802.16e™

**IEEE Standard for
Local and metropolitan area networks**

**Amendment 2: Physical and Medium Access
Control Layers for Combined Fixed and Mobile
Operation in Licensed Bands**

**IEEE Std 802.16e™-2005 and
IEEE Std 802.16™-2004/Cor1-2005**
(Amendment and Corrigendum to
IEEE Std 802.16-2004)

Figure 11—PHS signaling example

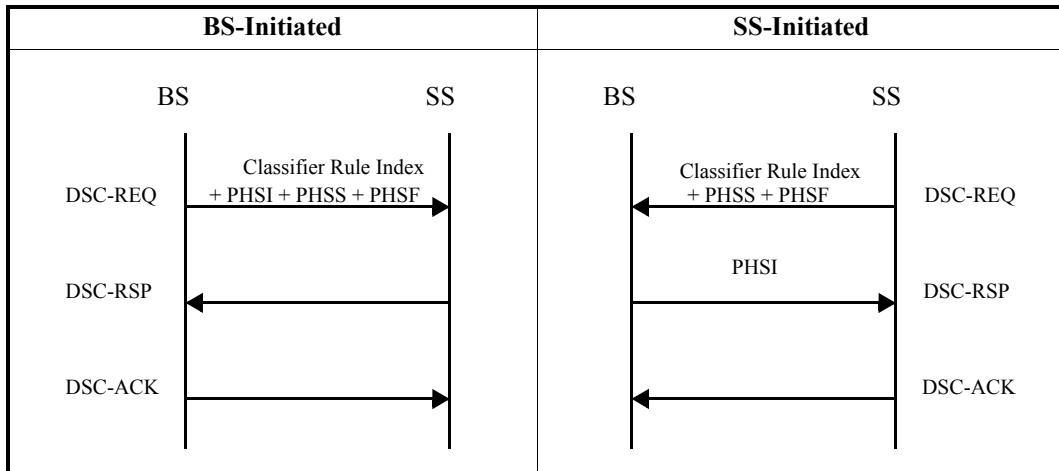
Replace Figure 11 with the following figure:

Figure 34—ARQ Reset message dialog—transmitter initiated

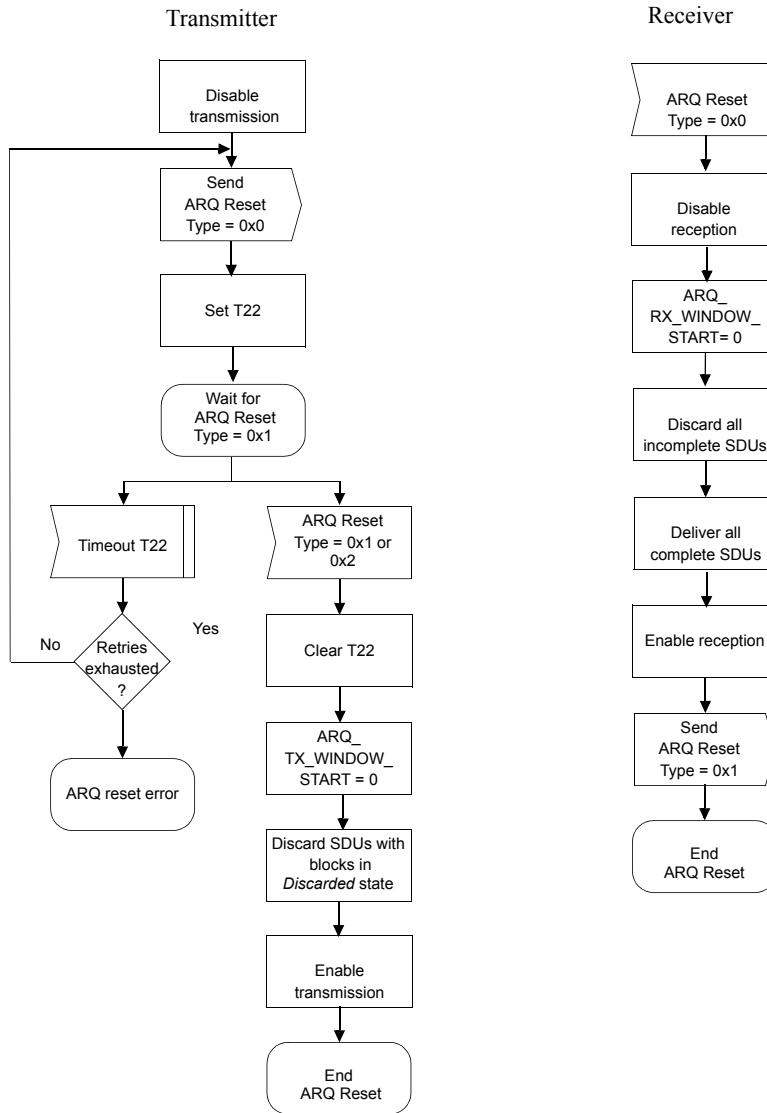
Replace Figure 34 with the following figure:

Change the last sentence of the paragraph below Figure 34 as indicated:

When the timer exceeds the value of ARQ_SYNC_LOSS_TIMEOUT, the transmitter state machine shall initiate a reset of the connection's state machines as described in Figure 3534.

Figure 35—ARQ Reset message dialog—receiver initiated

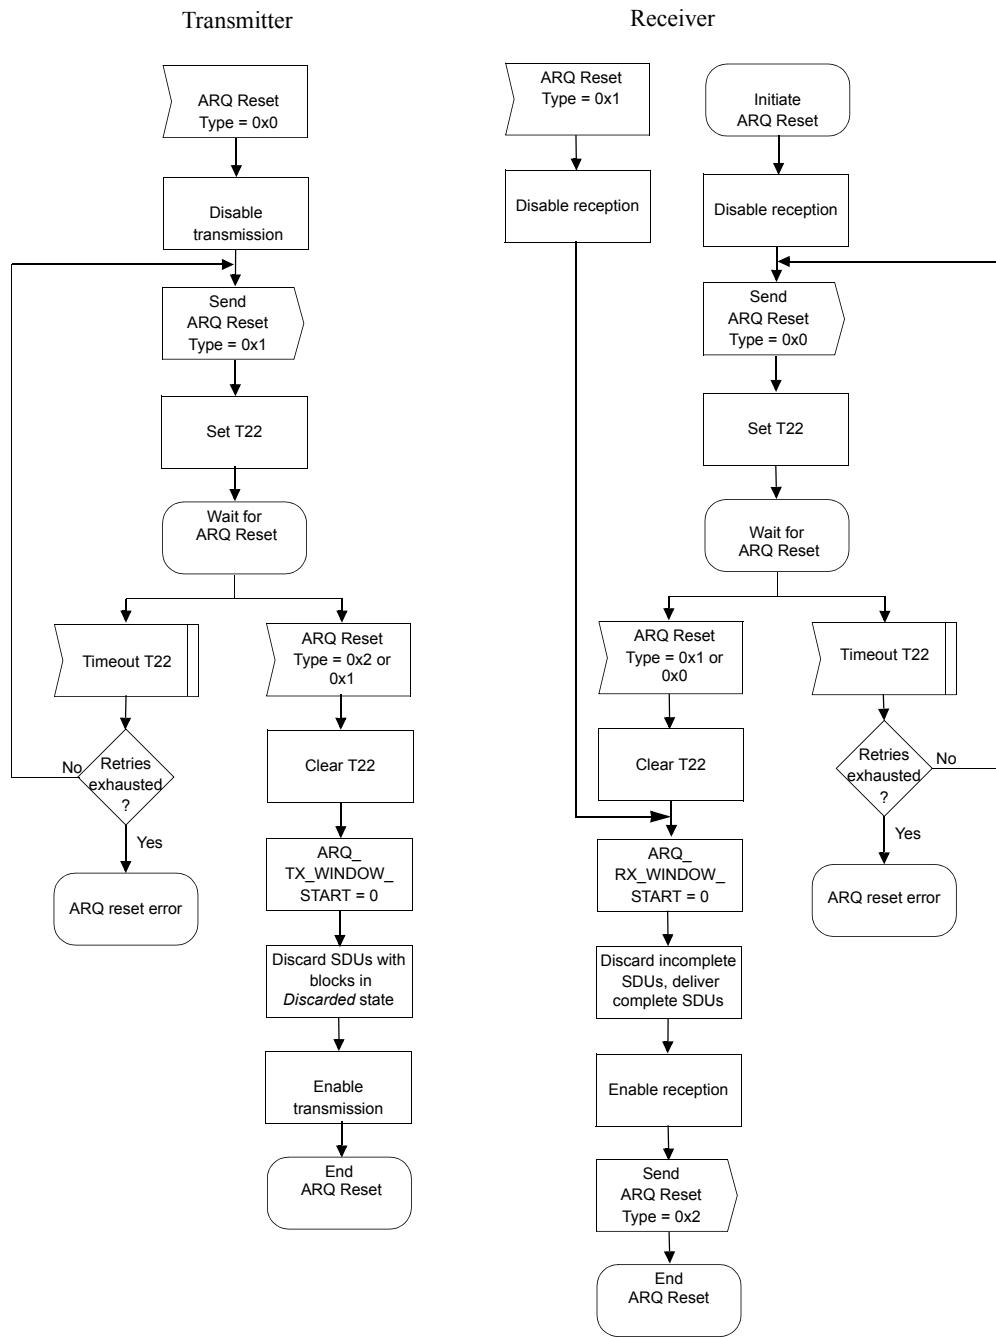
Replace Figure 35 with the following figure:

Insert the following sentence below Figure 35:

When in ARQ reset error state in Figure 34 and Figure 35, the SS shall re-initialize its MAC, the behaviour for BS is implementation dependant.

Figure 36—ARQ block reception

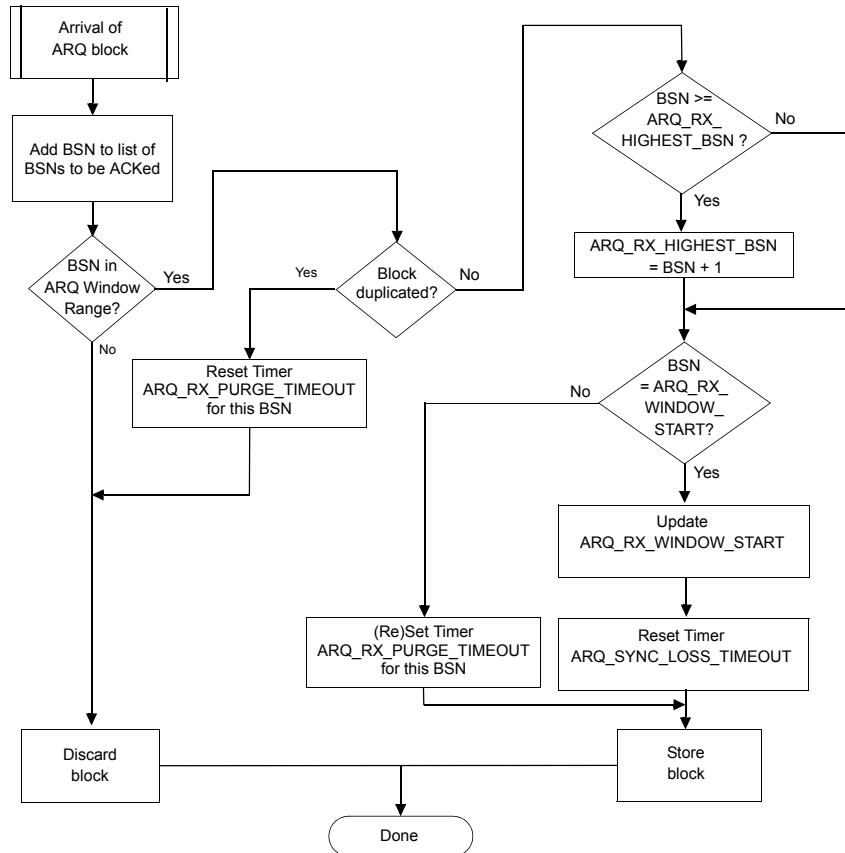
Replace Figure 36 with the following figure:

Change the first sentence of second paragraph below Figure 36 as indicated:

Figure 61 – Initial Ranging – SS (part 2)

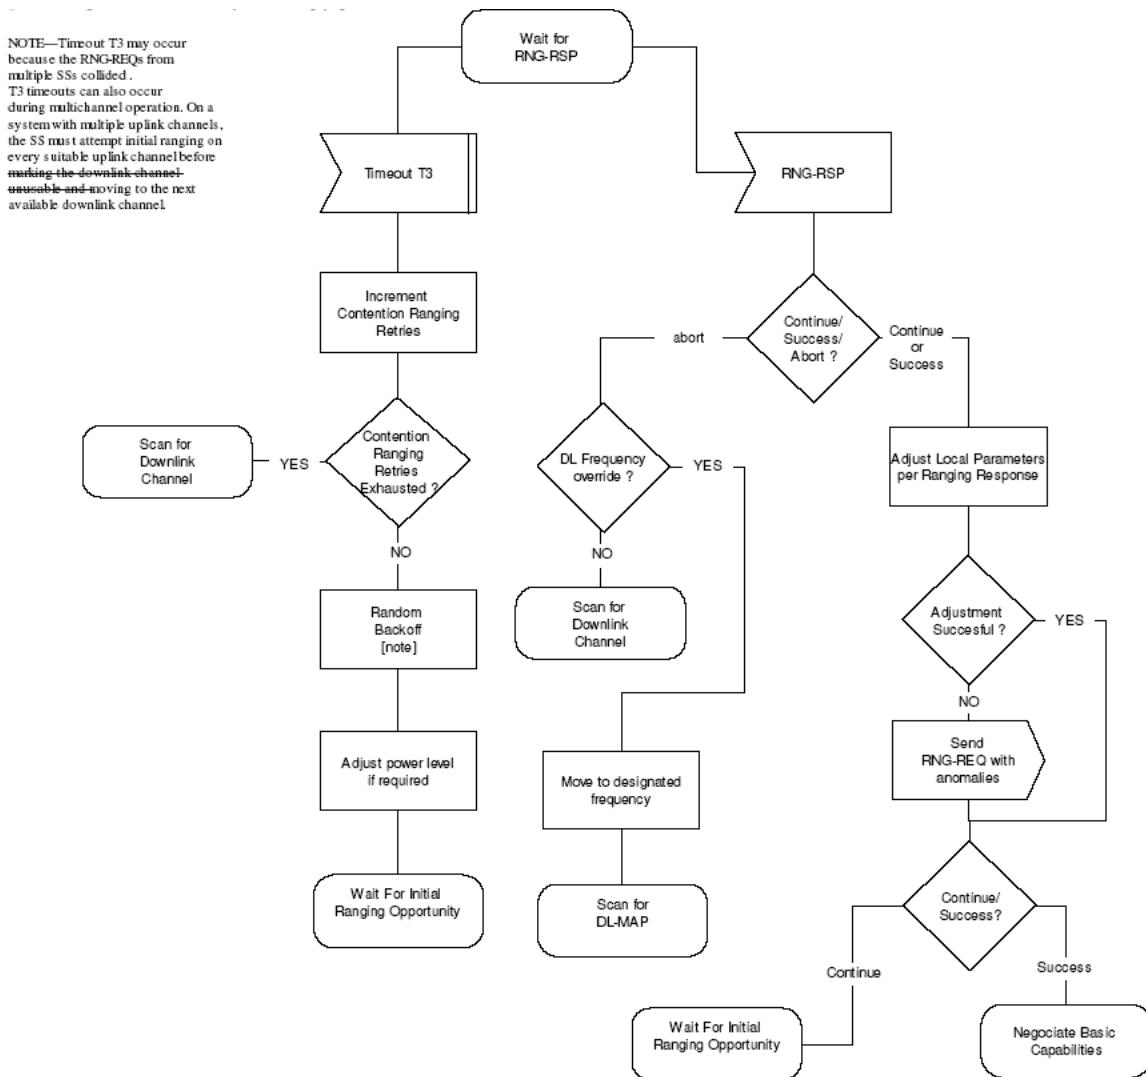
Replace Figure 61 with the following figure:

Figure 70—Registration—BS

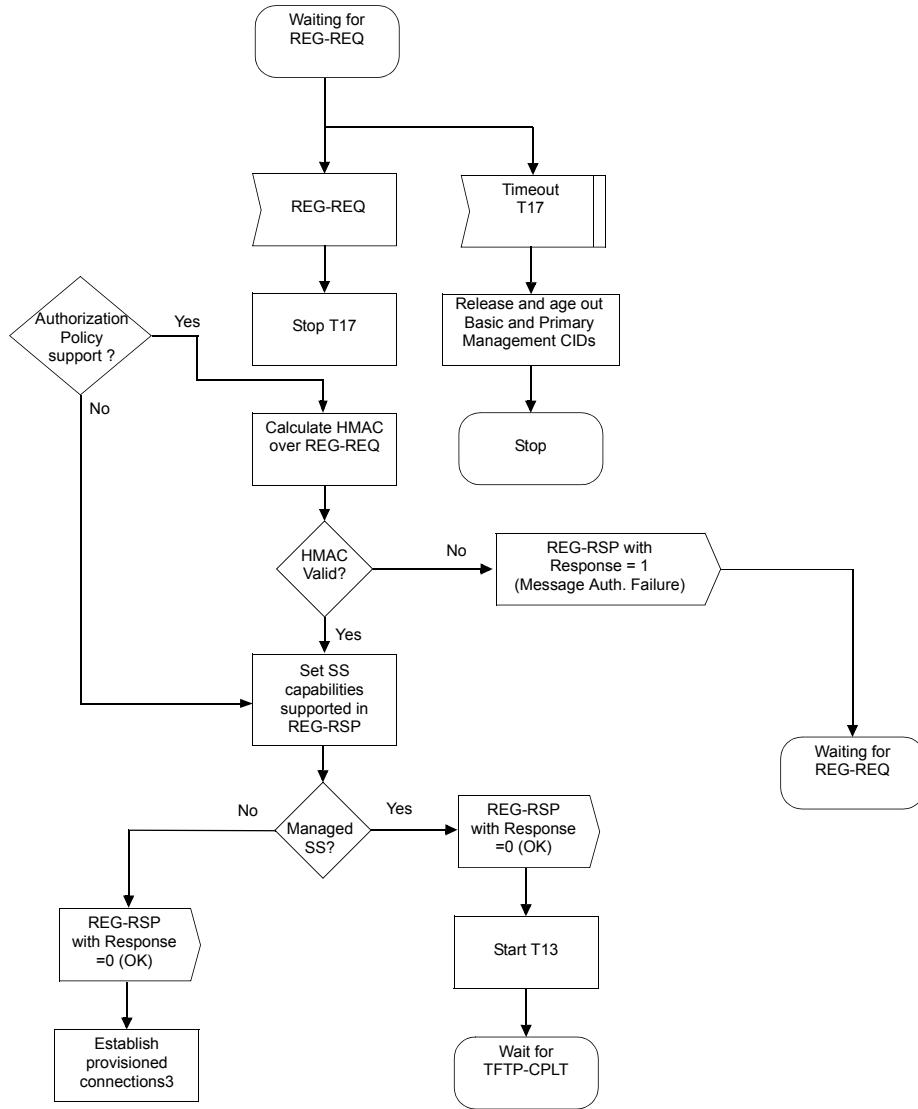
Replace Figure 70 with the following figure:

Figure 80—Transition to a less robust operational burst profile

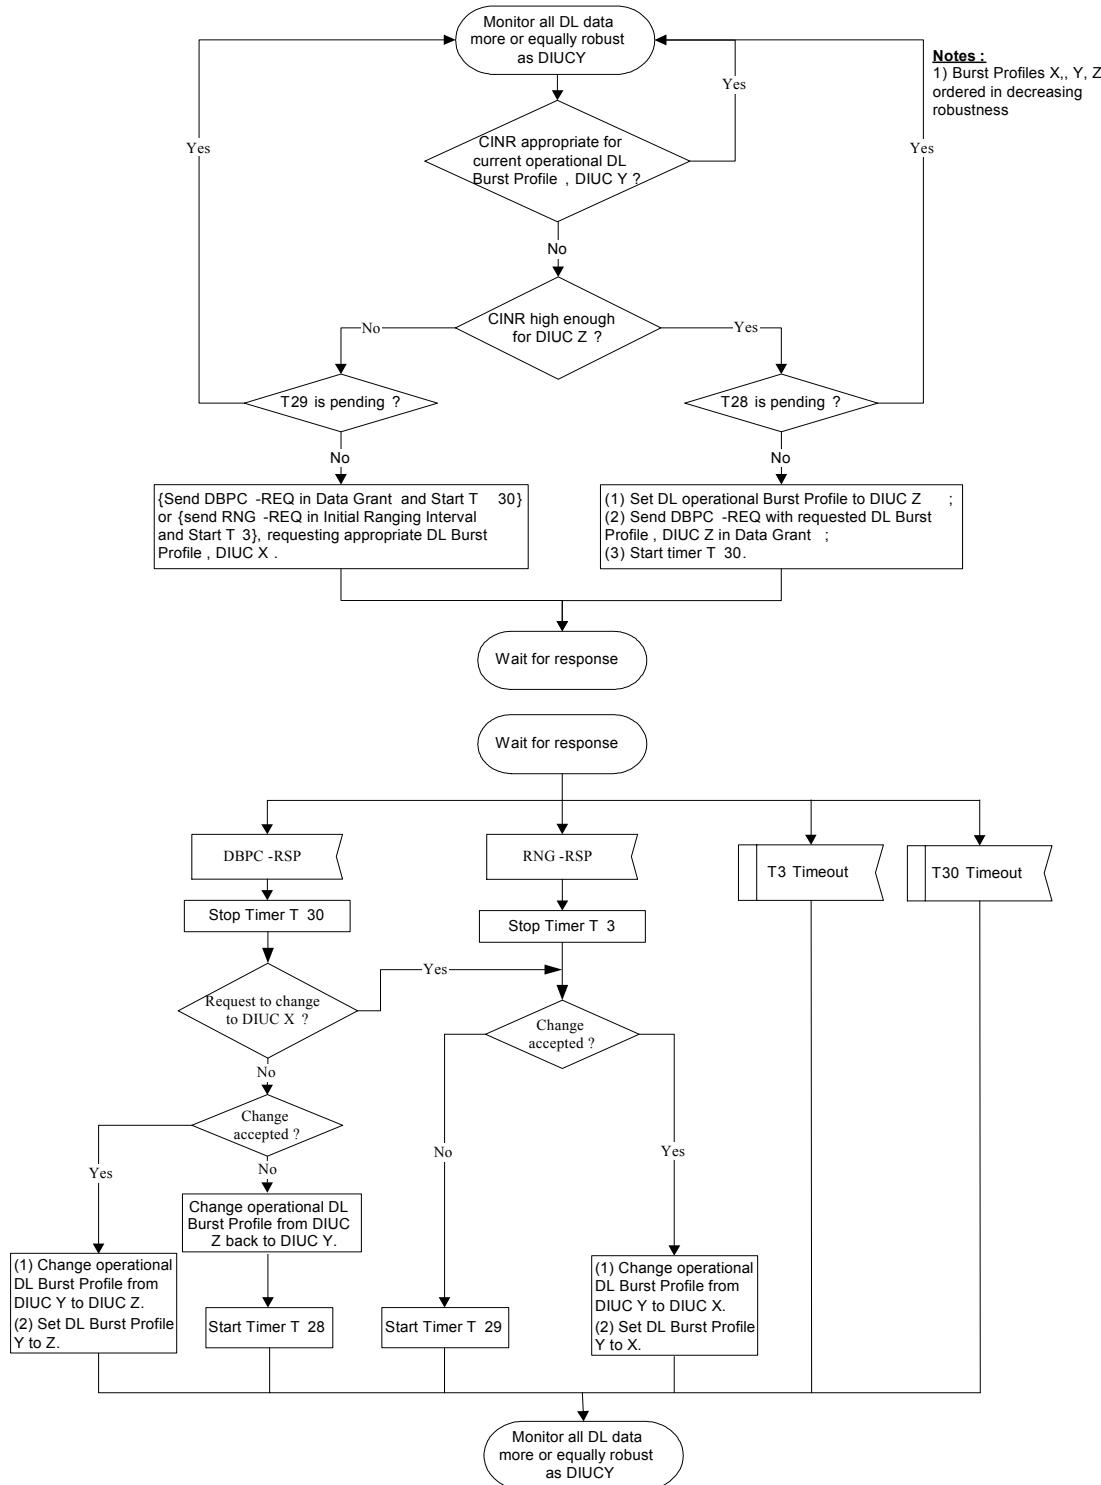
Replace Figure 80 with the following figure:

Figure 82—Periodic Ranging receiver processing—BS

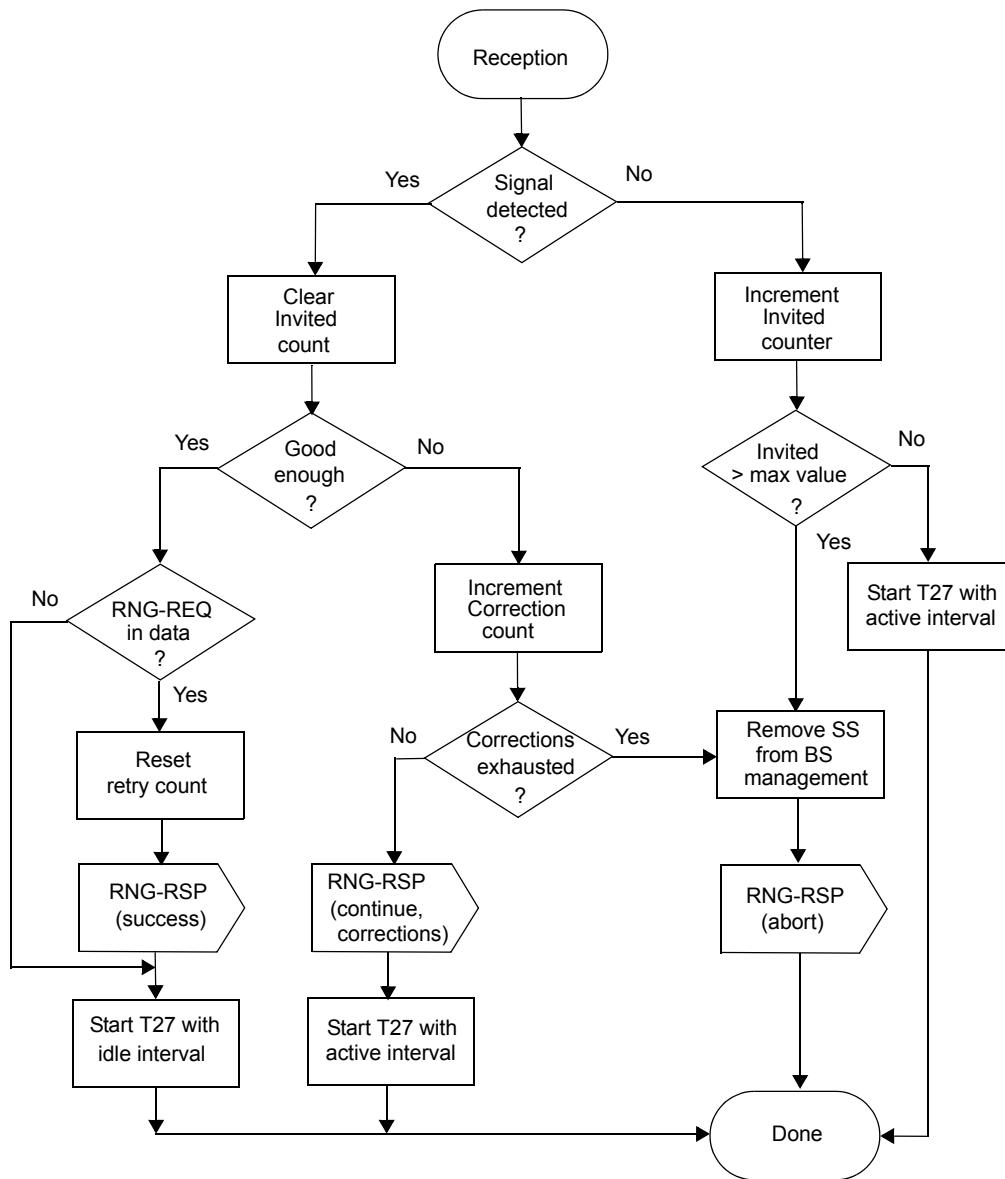
Replace Figure 82 with the following figure:

Figure 84—Periodic Ranging—SS

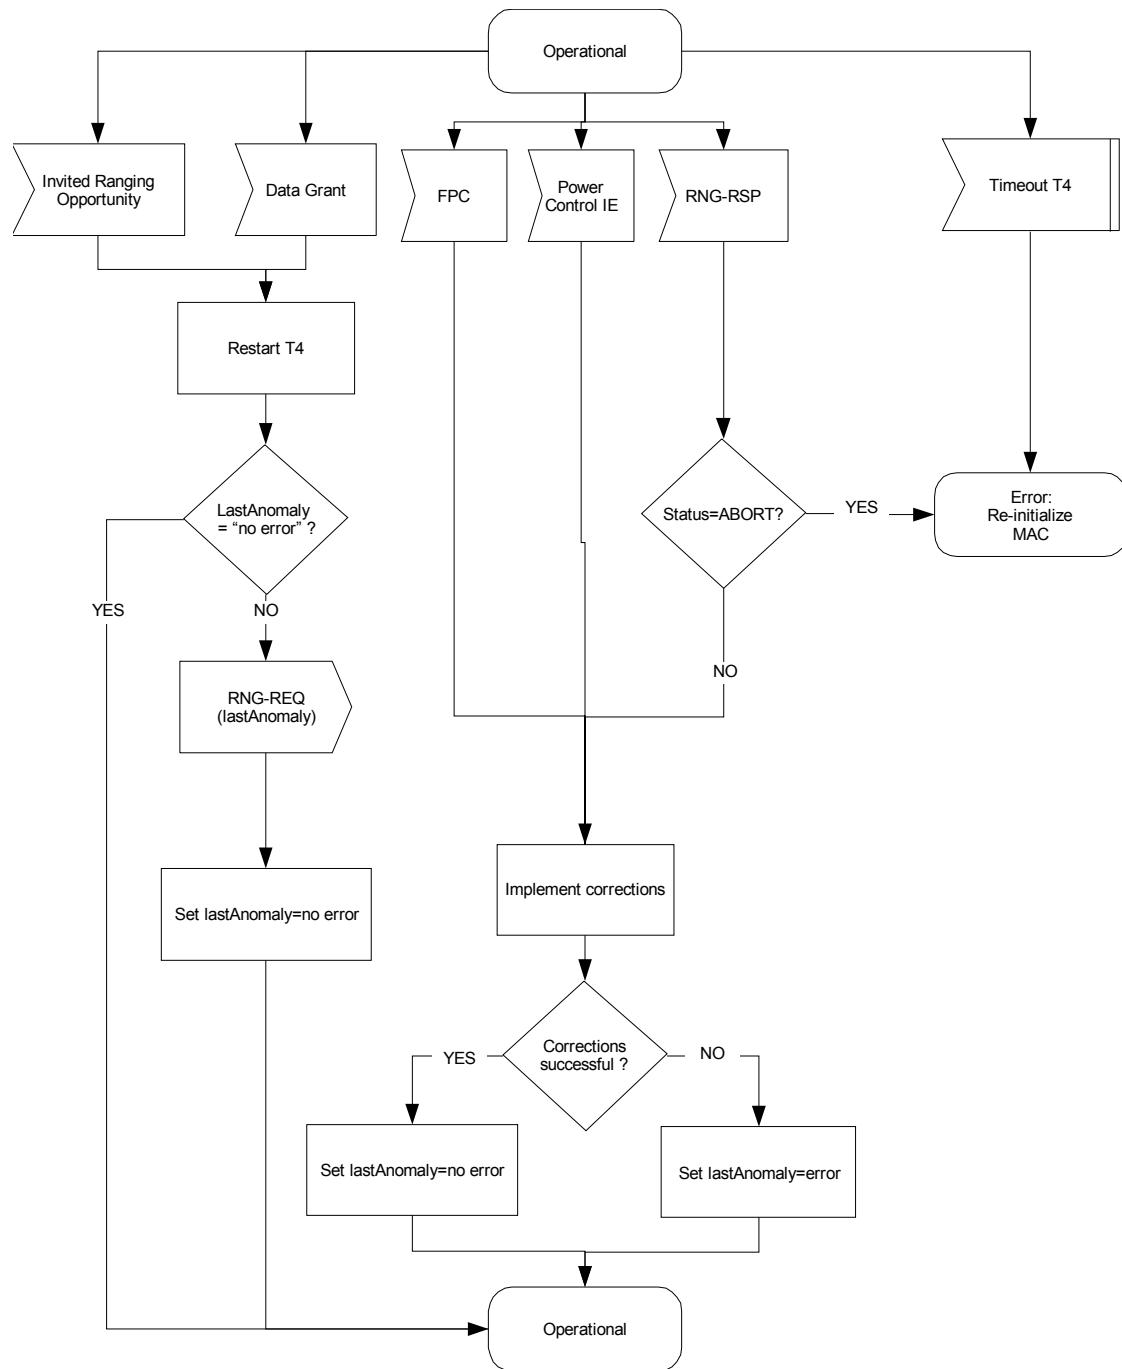
Replace Figure 84 with the following figure:

Figure 86—CDMA Initial Ranging—SS (part 2)

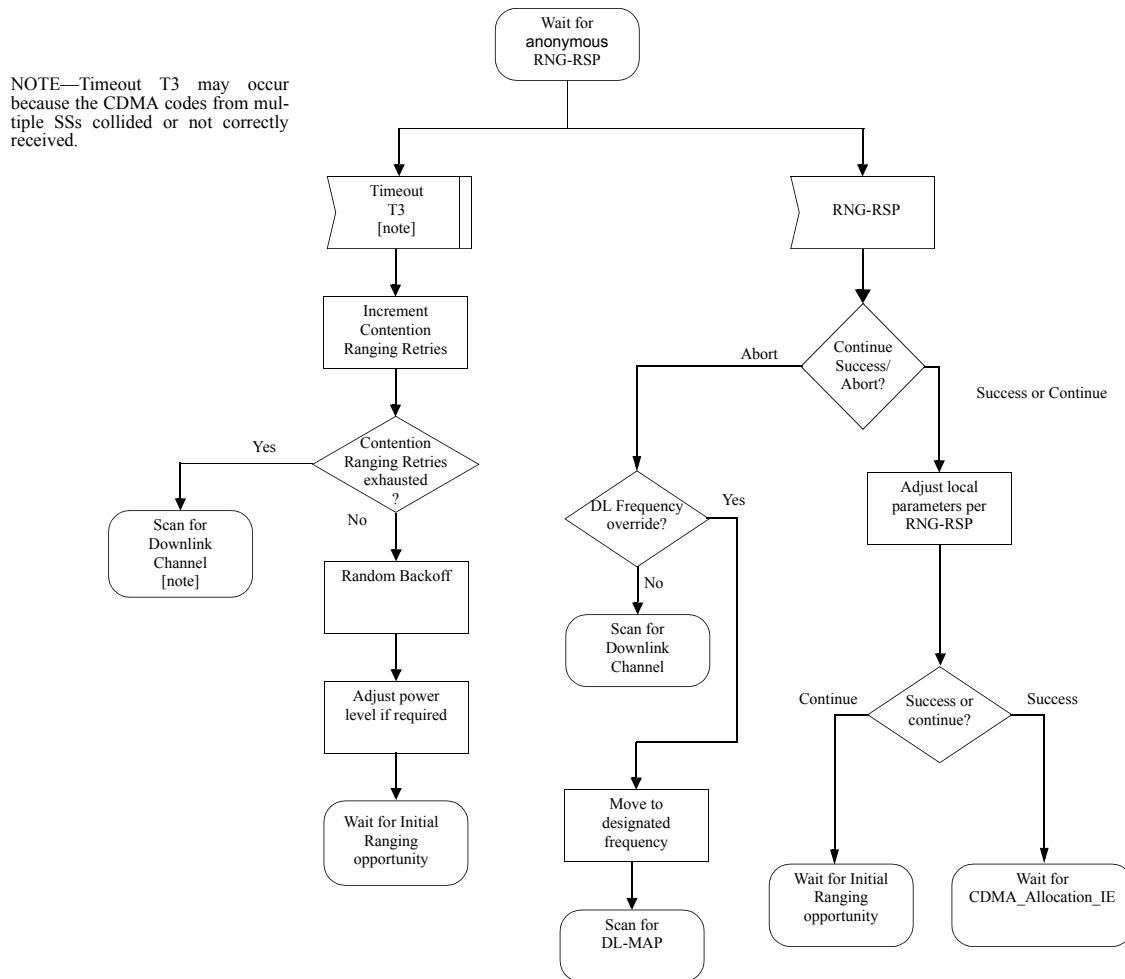
Replace Figure 86 with the following figure:
